July 10, 2025

### Addendum No. 2

#### **Diablo Road Trail and Drainage Improvement Project Project No. C-055**

**SOLDIER PILE WALL #1 PROFILE**  
SCALE: 1"=10' (HORIZONTAL); 1"=5' (VERTICAL)

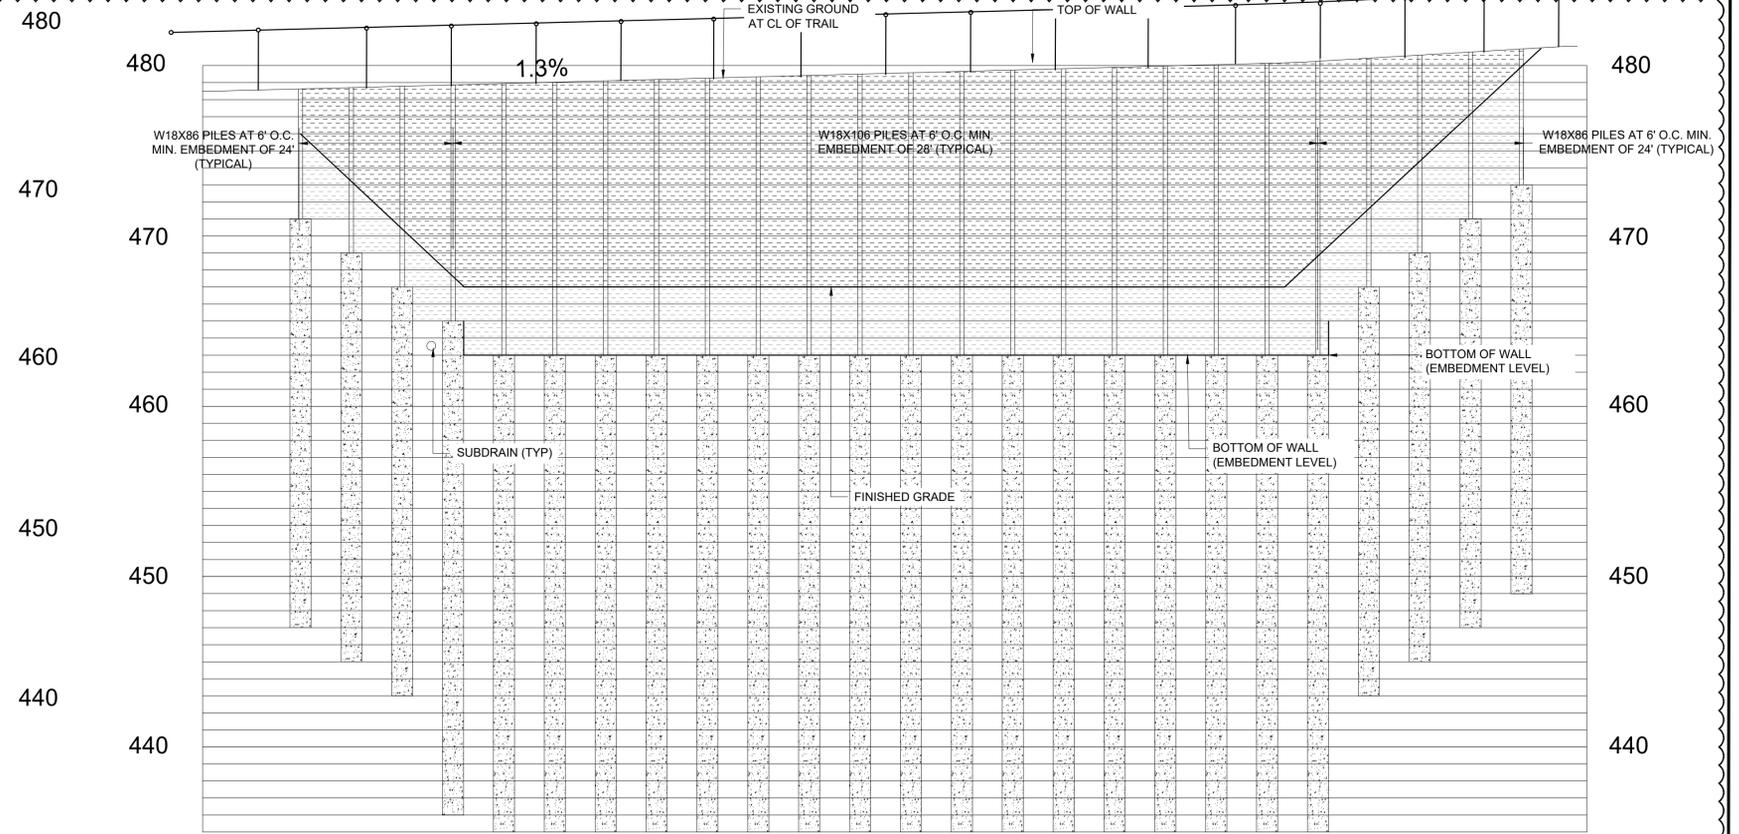
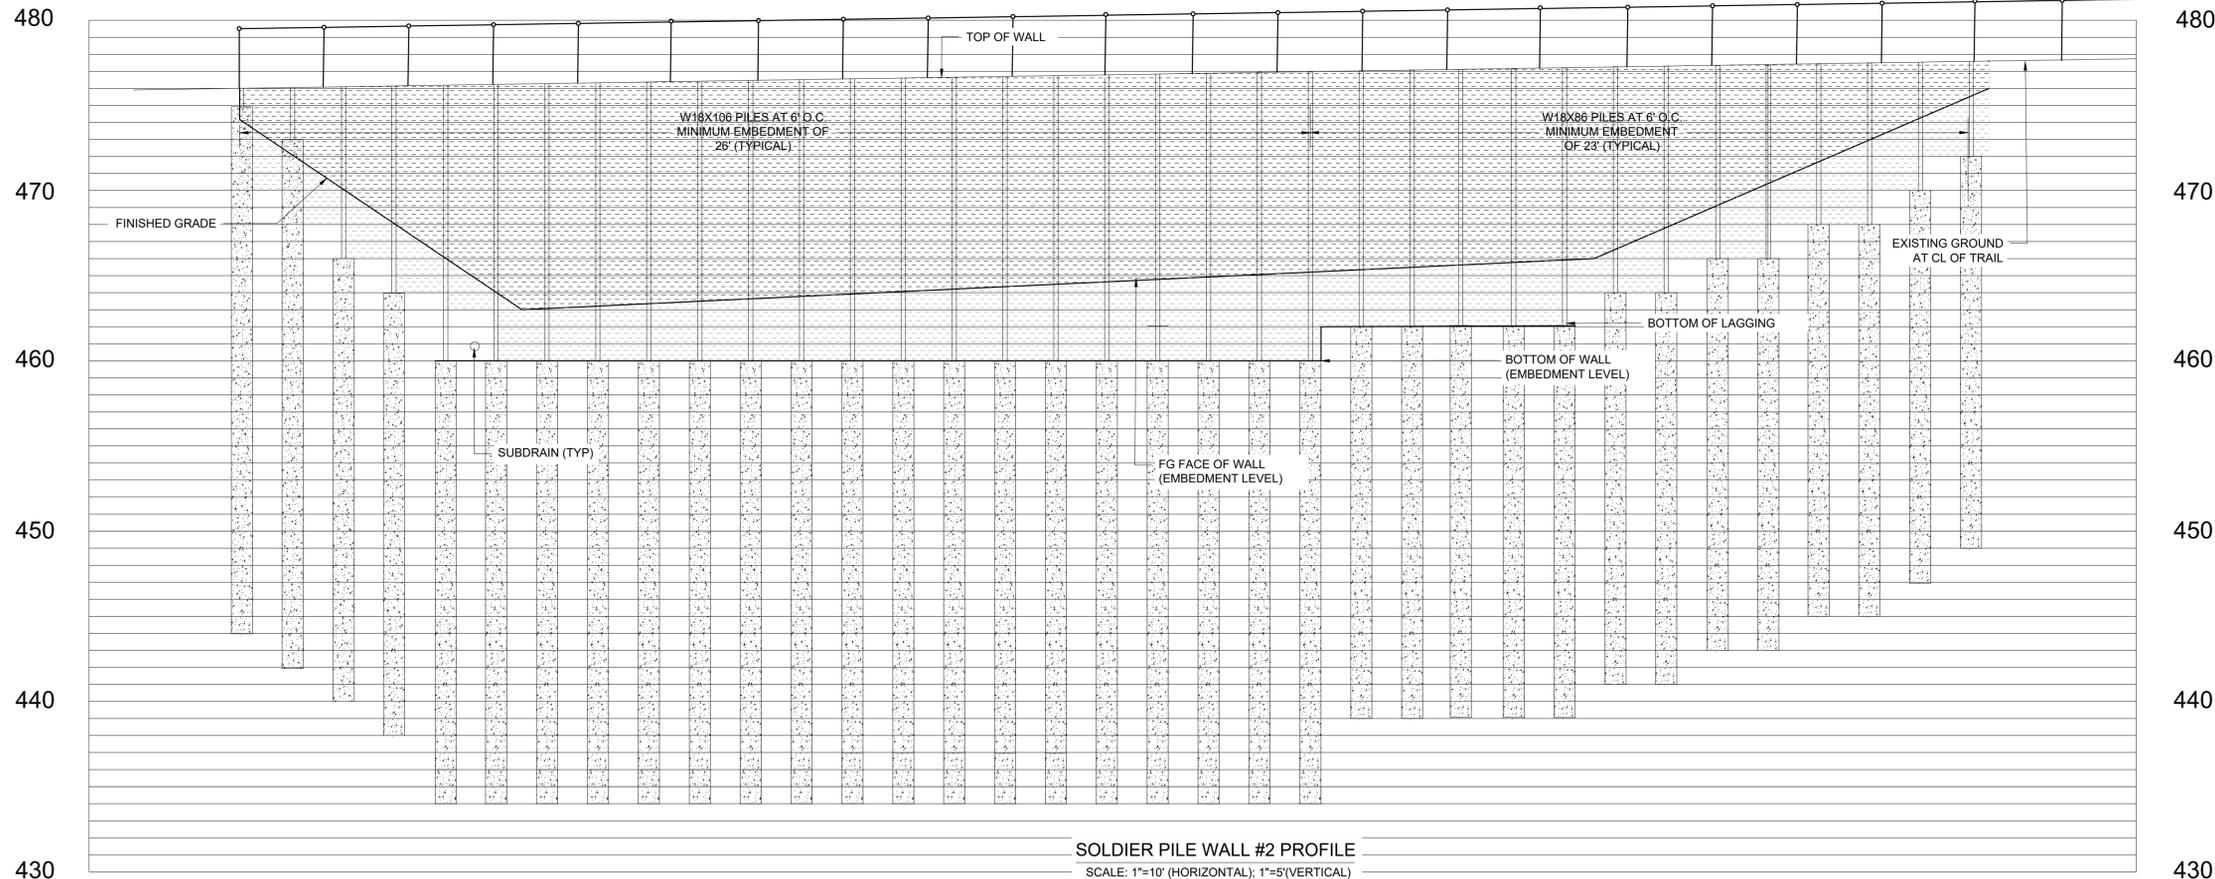
69- Soldier Pile Wall #2 (Plan Sheet 17) calls for W18x186 steel beams. These beams do not exist. Please confirm which steel beams are to be used in lieu of the W18x186 beams.

94-Profiles Shown on Sheet 17 show the Profiles for Soldier Pile Walls #1 - #3. All of them show the top of wall Precast Concrete Lagging matching the contour of the new path. Cutting the concrete lagging to match would be an arduous task. Could the City please consider a different design option for the top of Soldier Pile wall(s)?

- a. We have slightly modified embedment depths shown on the plans in Amendment 2 and lagging layout. Lagging may be eliminated that is founded below the top of concrete piles

- a. In addendum 2, we have added provisions to allow timber lagging at the top course of the wall where sloping gradient exist.
